March 5, 1996
Fort St. Vrain
P-96009

SUBJECT: Response to NRC Questions Regarding PSCo's Proposed Revisions to Final Survey Plan For Survey of Piping Systems and Suspect Affected Survey Units

Attachment to P-96009

The following are PSCo/WT's responses to the NRC's Comments on 1) our October 12, 1995, submittal (P-95077) "Fort St. Vrain Final Survey Plan for Site Release, Proposed Revisions for Survey of Piping Systems and Suspect Affected Survey Units," and 2) the November 15, 1995, submittal (P-95102) "Fort St. Vrain Technical Basis Documents for Piping Survey Instrumentation:"

**ATTACHMENT 1 TO PSCo/WT RESPONSE
TO NRC COMMENT NUMBER 10**

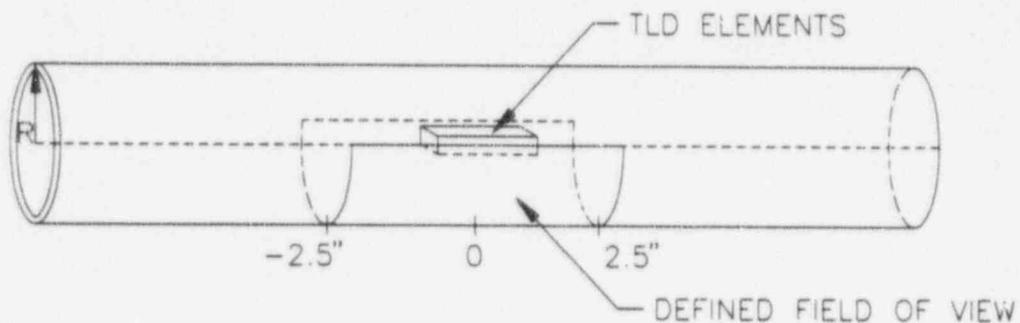
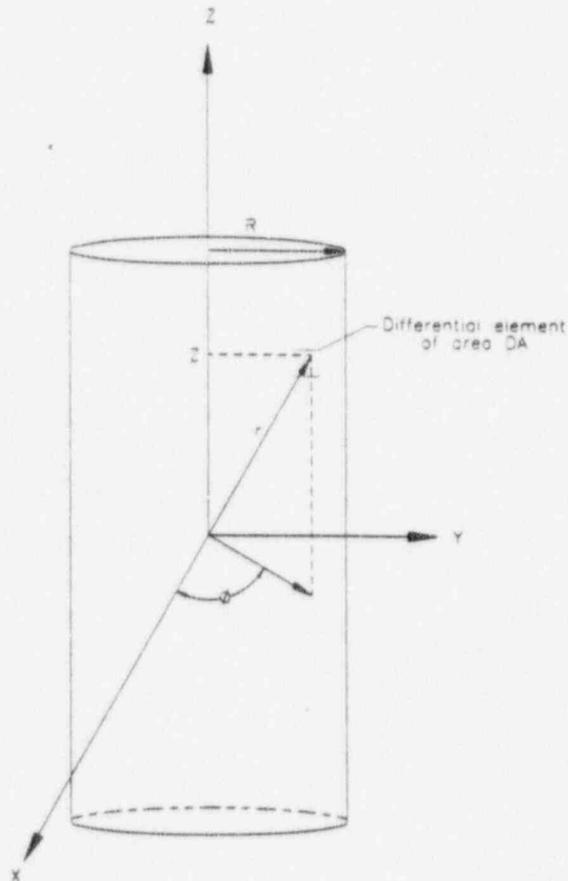
NRC Comment No. 10: Regarding TBD-203, Page 4, Paragraph 2:

To determine whether a 20" spacing for TLDs on a string is appropriate and to estimate the uncertainty and upper bound for maximum piping contamination levels, an analysis of the FSV Equipment Storage Well survey data taken at 20 inch intervals was performed and is included as Attachment 2 to this Comment Response. PSCo/WT divided the measurements into sets of measurements spaced 40, 60, and 80 inches apart, thereby providing four data sets. Estimates of uncertainty, mean values, and the upper bound for maximum contamination level were evaluated for each of these data sets. The attached pages present the details of this evaluation. The result was that with TLDs spaced at 20 inch intervals, the estimated uncertainty is $\pm 22\%$ at the 95% confidence level for maximum measured contamination level. This level of uncertainty supports the suitability of an investigation level at or below 75%. Therefore, TLD surveys of FSV embedded piping using 20" spacings and investigations at 50% of the embedded piping bounding limit of 100,000 dpm/100 cm² (i.e., 50,000 dpm/100 cm²) are reasonable and appropriate.

This evaluation is performed to estimate the response of a TLD centered in a small diameter pipe to highly localized contamination (i.e., a point source). An Inverse Square model was used to estimate the relative response from a point source located at various positions relative to the centered TLD. It is recognized that this is a simplified model that does not incorporate all factors that could affect the overall response of a TLD to a localized source. However, since an inverse square reduction with increasing distance is a dominant factor, it is considered useful to provide a reasonable estimate of relative TLD response to a point source. Using this model, maximum over and under response factors and the fraction of total response to the TLD for various field of views are determined.

As shown in Table 1, 90% of the TLDs total response (based on an inverse square model) comes, on average, from about 115 cm² (i.e., about 90 cm² for 1 inch diameter piping and 140 cm² for 2 inch diameter piping). Therefore, the FSV defined field of view of 100 cm² for TLDs is reasonable. Although, the maximum under and over responses from point particles can be more significant for TLDs (or any small detector) than for a larger flat faced detector near a surface, these factors were calculated for a theoretical worst case distribution (i.e., an infinitely small point source in an otherwise clean pipe). If localized contamination is more extensive in physical size than a pure point source, the uncertainty in a given measurement is reduced. Actual TLD survey data from contaminated piping at FSV indicates when contamination levels are high (e.g., greater than SGLVs), contamination is likely to be more extensive than sparsely spaced point particles. Therefore, the methods of survey and data analysis used for TLDs at FSV are appropriate.
